Customer Process Change Notification Form

PCN-2013-497

CS5484-INZ(R)

Errata: CS5484 Rev B2 Silicon

Figure 1. Chip Select Pin \overline{CS} Model

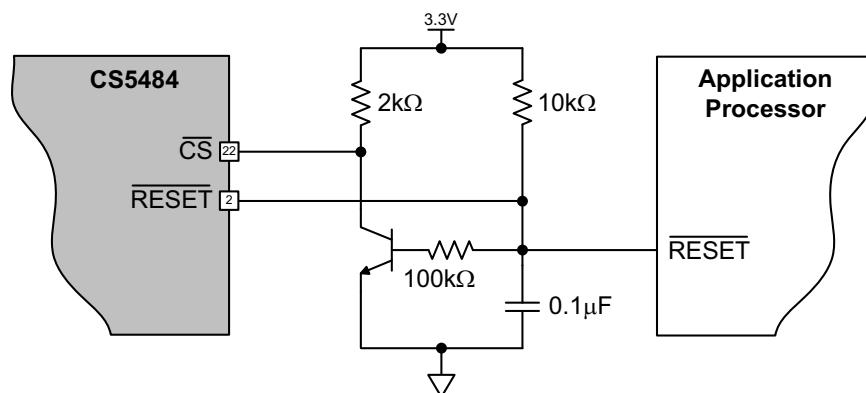
Erratum 3 - Serial Peripheral Interface Communication Synchronization Error

This erratum applies only to designs with chip select pin \overline{CS} tied low. If Serial Peripheral Interface (SPI) communication is interrupted, a synchronization error may occur on future SPI communications. A standard reset does not clear the SPI logic and correct this synchronization error.

Chip select pin \overline{CS} must be toggled to reset the SPI Interface. A NPN inverter may be added to the \overline{RESET} signal to obtain a suitable CS signal to reset the SPI Interface without the need for additional isolators. When the device is reset, using \overline{RESET} , the serial peripheral interface is also reset.
